Objection:

From the Brecon and Radnor Branch of the Campaign for the Protection of Rural Wales

20/0717/FUL: Erection of 2 no. agricultural buildings for the housing of broilers, erection of feed bins, formation of vehicular access together with all other associated works: Cwmafan Llanafanfawr Builth Wells LD2 3PF

OS Map containing manure-spreading area for Cwmafán 100,000 broiler application.

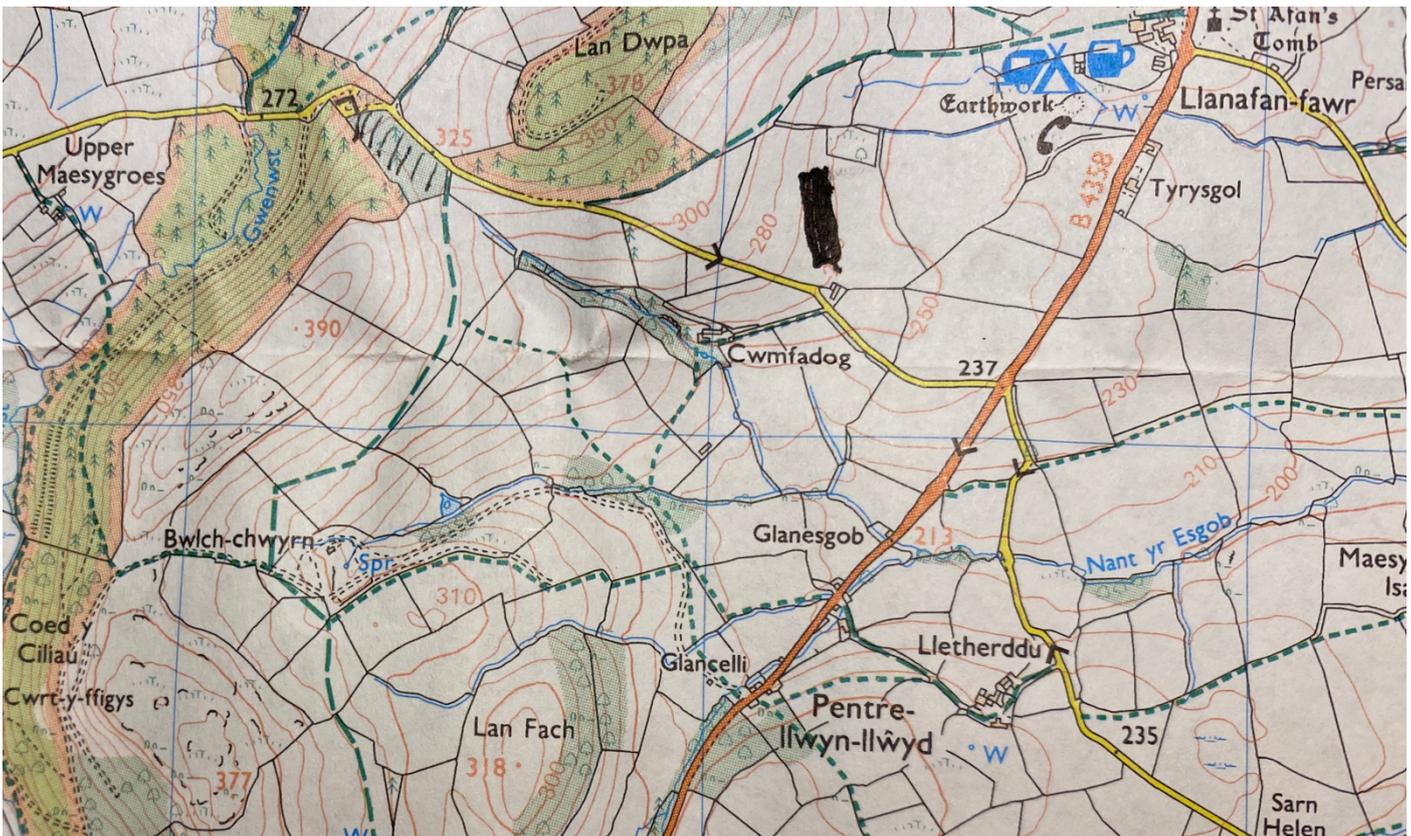
Reference to the 1:250,000 OS Map shows that nearly all the land to the West (left) of the uncoloured area surrounding Cwmfadog is steeply sloping down to the watercourses which reach a confluence near Glanesgob, forming the Nant yr Esgob, a tributary of the Chwefri.

There can be no doubt from the OS contours that most of this land should be red, orange or yellow as the slope appears to range between 1:5, or steeper, and 1: 14. The MMP describes:

'Red = No-spread areas, e.g. yards; within 10 metres of a watercourse or 50 metres of a borehole, spring or well used for drinking or parlour washings. Or Areas not normally used for operational reasons but may be brought into use in the future.

Orange = Very High Risk. Steeply sloping fields of gradients 1 in 7 to 1 in 5; fields at risk of flooding; sandy or shallow soil over fissured rock; fields where drains have been installed during the past 12 months; poorly drained or waterlogged land; severely compacted soils, etc.

Yellow = Moderate Risk. Slopes between 1 in 14 to 1 in 8; land sloping towards watercourses; imperfectly drained land.'

From 20 0717 FUL-PHOTOMONTAGES-324906

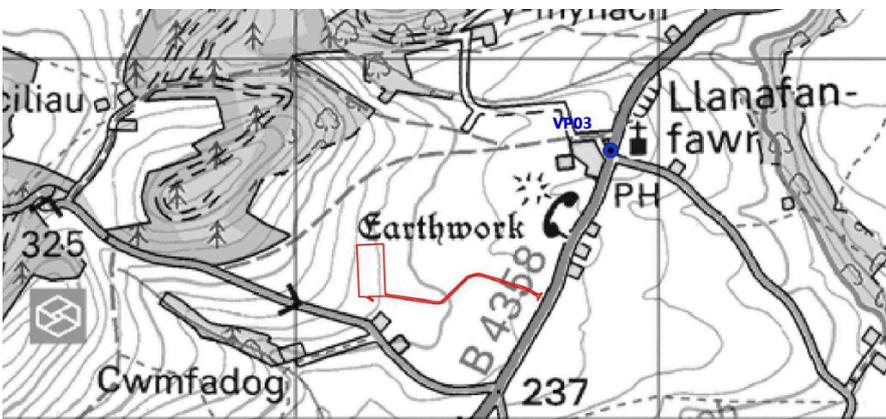
The ES landscape analysis in Ch 7 contains a great deal of generic text about applying a sensitivity/magnitude matrix which is never actually applied at all either by the landscape consultant Viento or by Roger Parry's author, G. Maxfield. The work presented amounts to an unjustified conclusion about impacts not being significant although the unit will be visible from some locations. The conclusion of ES p82 says '*The measures factored into the site selection and design process will reduce, minimise and even improve any potential adverse effects'* suggesting that the author believes the development will enhance the landscape impact and visual experience! Few who see the wireframe and montage from view-point 1 will agree.

- The photo montages do not properly display the extent of 150m x 75m hard-standing properly and do not include the 475m x 5m wide access road. The muted colours in the photograph do not do justice to the real impact on a human receptor under many conditions.
- The **High** LANDMAP classifications for **Visual and Sensory** and **Historic** aspect layers are reported but not given due recognition. The Cultural layer has never been assessed by NRW.

Section from 20_0717_FUL-APPENDIX_32_LANDSCAPE_REPORTS_MAPS_-324897

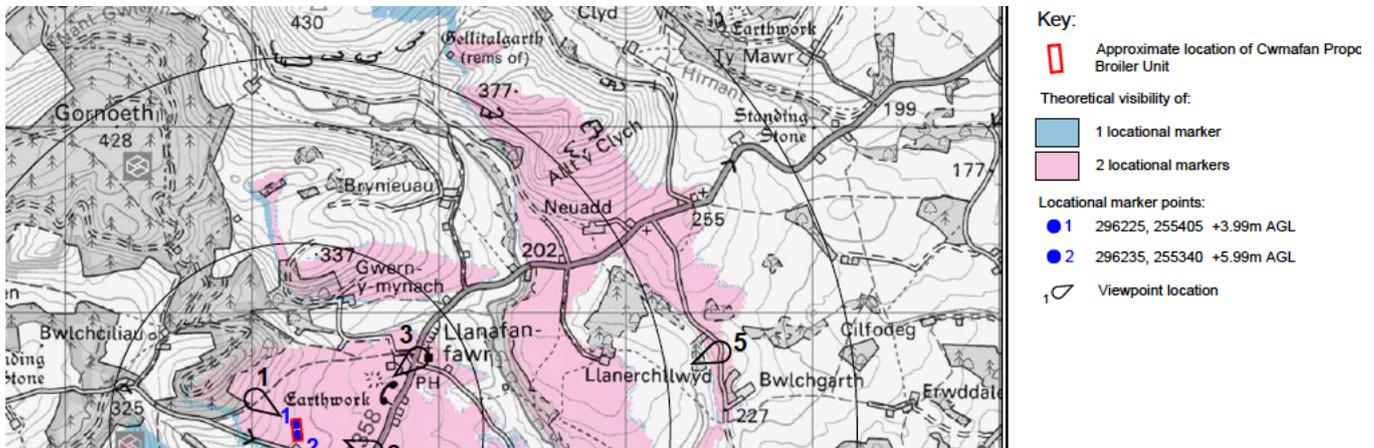
- The Public Bridleway location of VP1 'to East' is described as 200m from the site (CWMAFAN EIA APPENDIX 32 LANDSCAPE REPORTS (1) 29) but other plans (e.g. Landscape Reports 7) show it is much closer. The Bridleway climbs to 40 metres higher than the sheds and so a hedge, in the position shown in Landscape Report 3 above, would not provide effective mitigation.
- The ZTV maps 20_0717_FUL-APPENDIX_32_LANDSCAPE_REPORTS__MAPS_-324897 uses 2 locational markers of different heights (AGL) which do not appear to represent the full length of the sheds.
